## 1968 Corvette: Chevrolet Service News: 1968 Corvette Hood & Hood Lock Adjustment

**Subject:** Hood & Hood Lock Adjustment

**Model and Year:** 1968 Corvette **Source:** Chevrolet Service News

Page Number: 3
Date: August 1968

Fig. 2-Hood Lock Alignment Tool

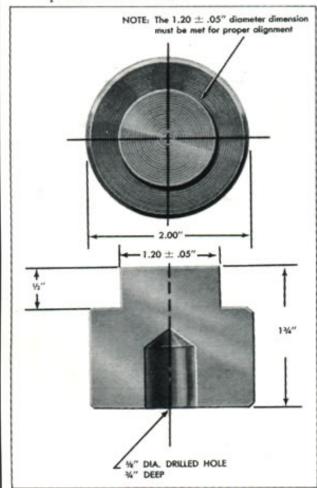
- To align the lock assemblies, perform the following:
  - a. Fabricate a tool as shown in Figure 2 from a 2" diameter x 15/4" long piece of steel, plastic or hard wood.
